ON-SITE SEWAGE DISPOSAL SYSTEM HOWARD COUNTY HEALTH DEPARTMENT BUREAU OF ENVIRONMENTAL HEALTH

ADDRESS: 5280 Ten Oaks Road PROPERTY OWNER: Mario Fiorino

P 37759
Repair
A 37759

Location Survey of #5280 TEN OAKS ROAD

A 37759

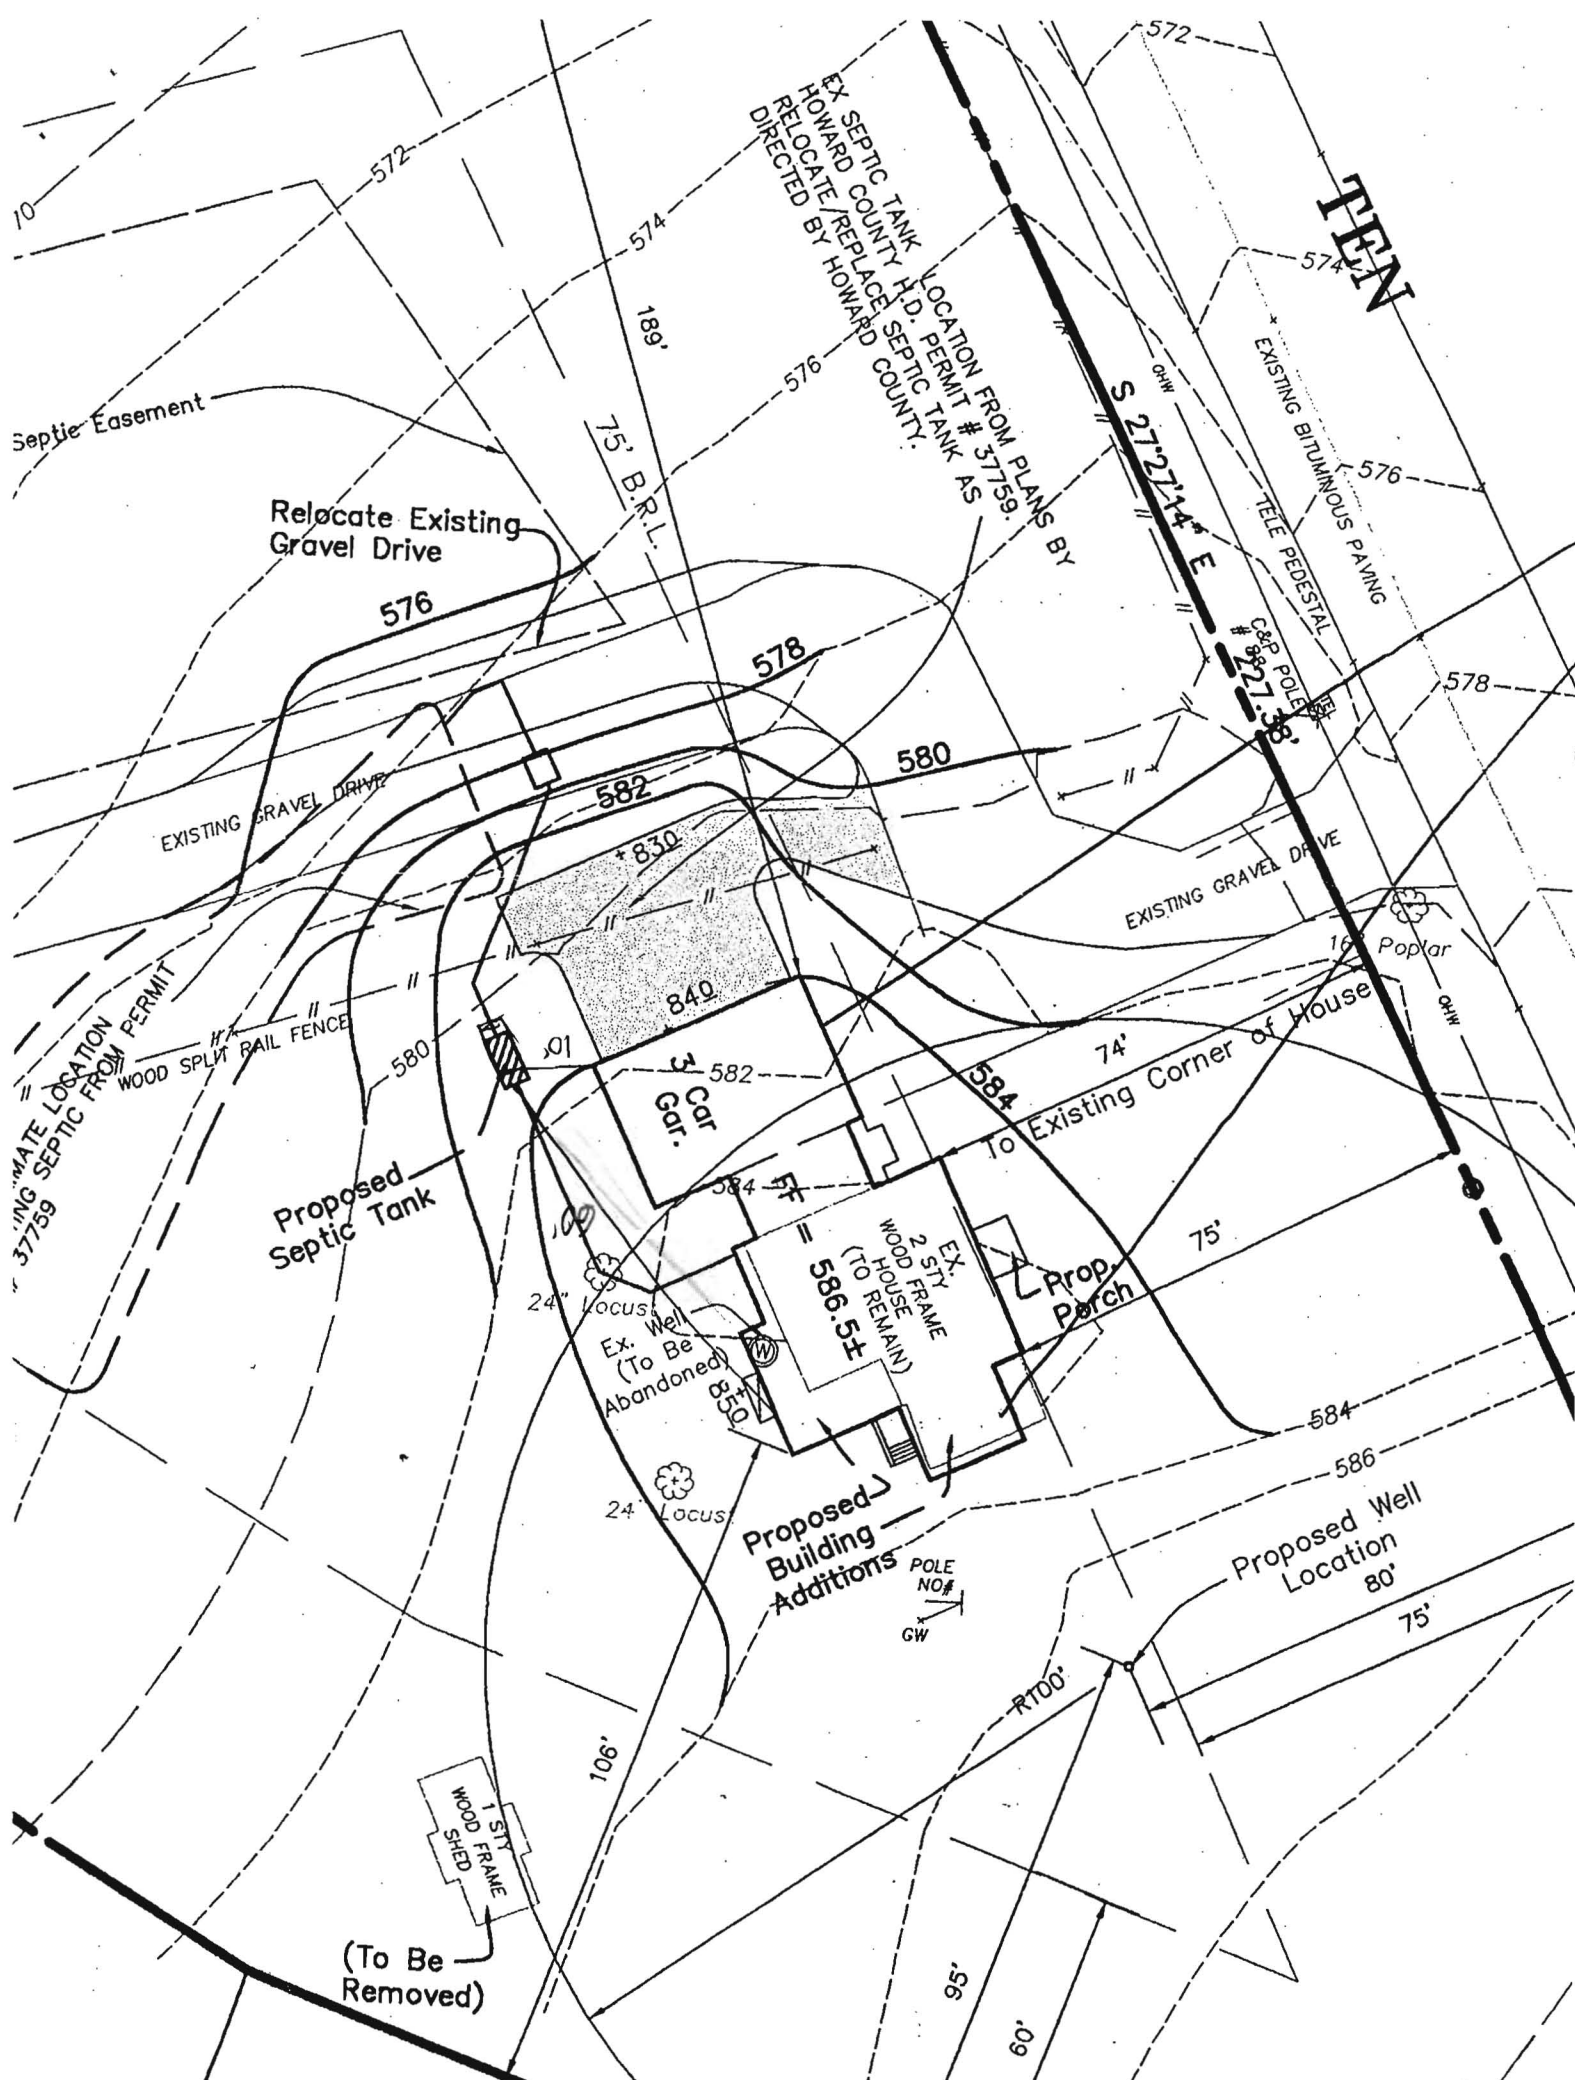
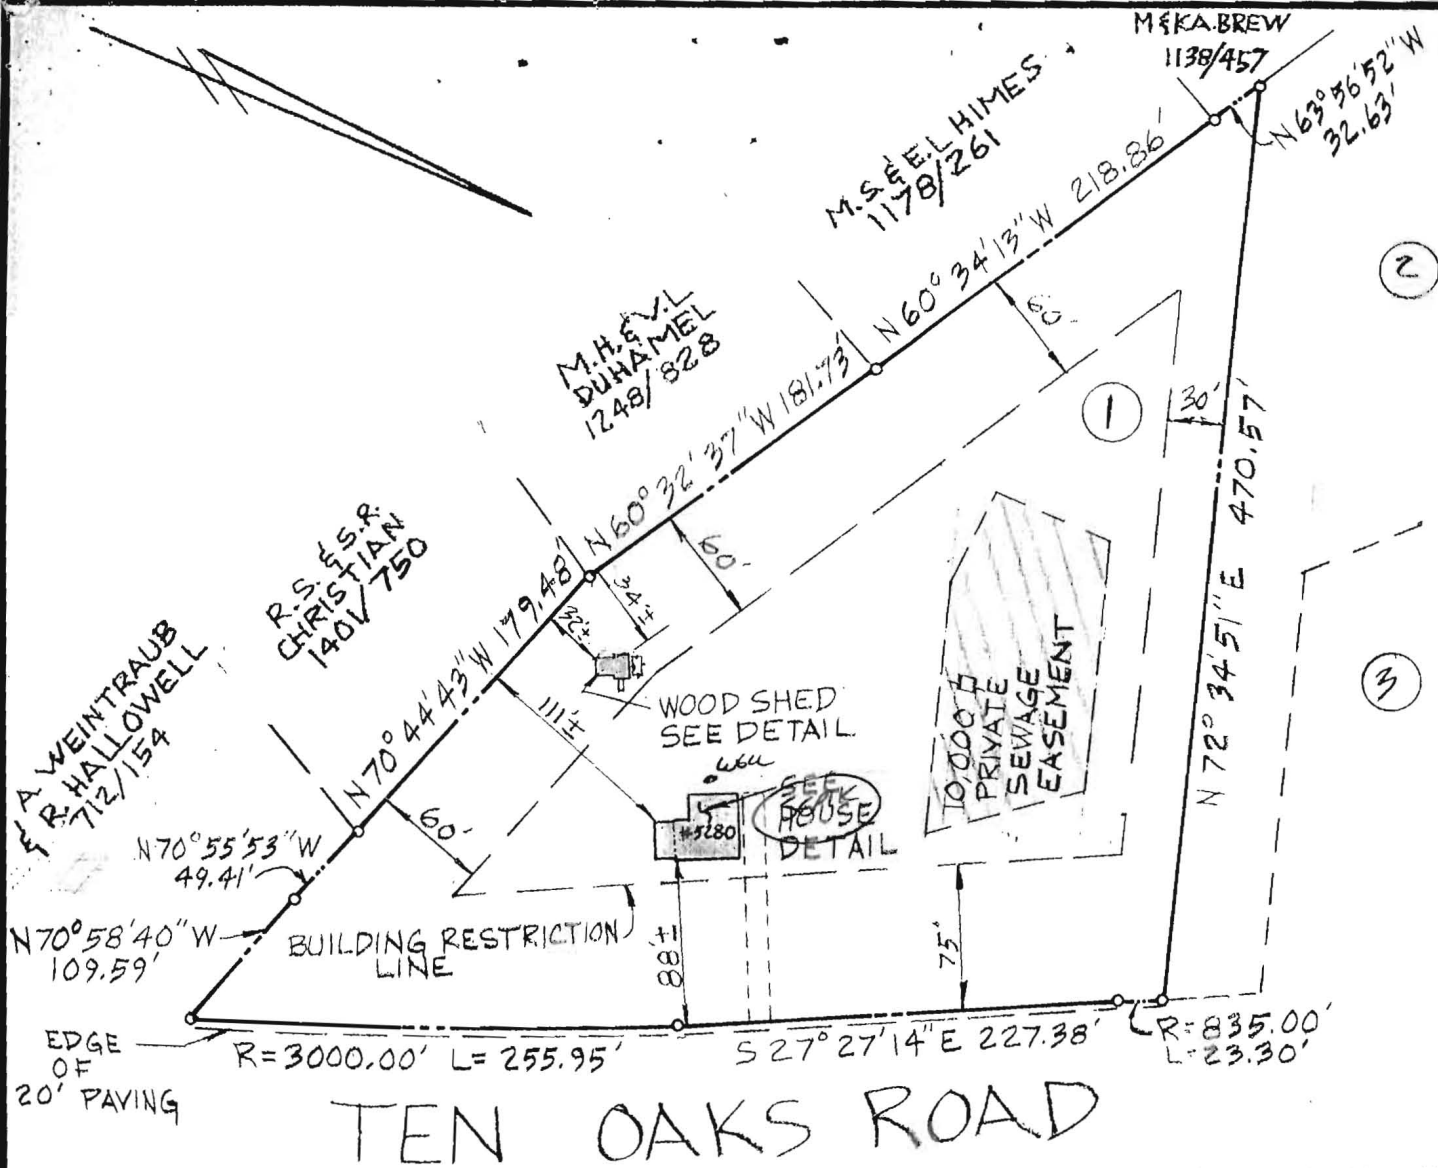
BLOCK TANK - IN DISREPAIR - UNCERTAIN CAPACITY PER CENTRACTOR.

MUST BE ABANDONED. 4/15/88 CW

INSTALL - 2-110 ft. long trenches. ORIGINAL SYSTEM TO BE ABANDONED

LOCATION - Distribution box to be placed minimum 15 feet below end of existing system.

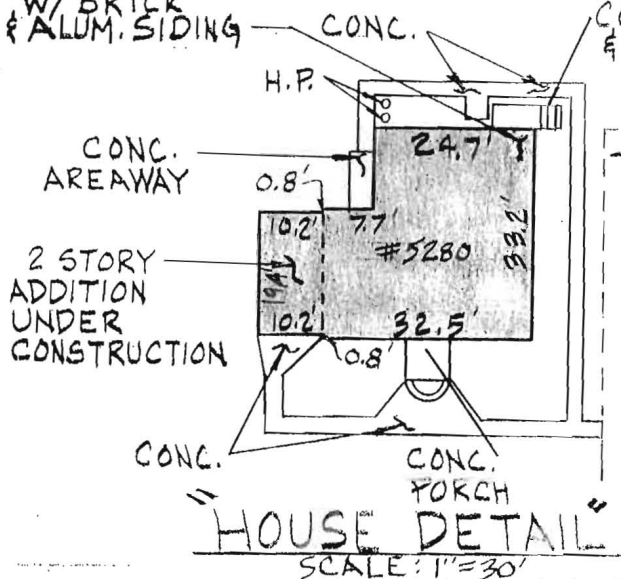
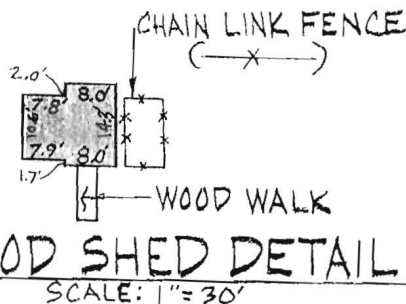
NO IMPACT -
REPAIR SYSTEM INSTALLED
4/21/88 TO
ACCOMMODATE THIS
ADDITION.
CONC. PORCH OK TO
& WALK PROCEED
